CONDITION OF CONCERN

On certain subject Mazda6 vehicles in salt belt states, it is possible the front cross member may be corroded due to suspected insufficient paint coating. Continued use of the vehicle may allow the corrosion to progress, causing the support of the right lower control arm to decrease. Passing over a pothole may result in breakage of the cross member and reduced steering control, increasing the risk of a crash.

SUBJECT VEHICLES

Support brace

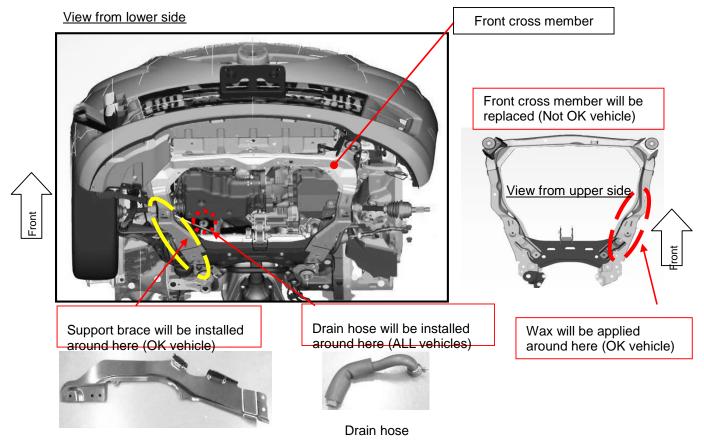
- OK vehicle: If the cross member passes inspection, install a support brace and A/C drain hose, and apply anti-rust cavity wax to the cross member.
- Not OK vehicle: If the cross member fails inspection, replace the cross member with a modified one and install a drain hose.
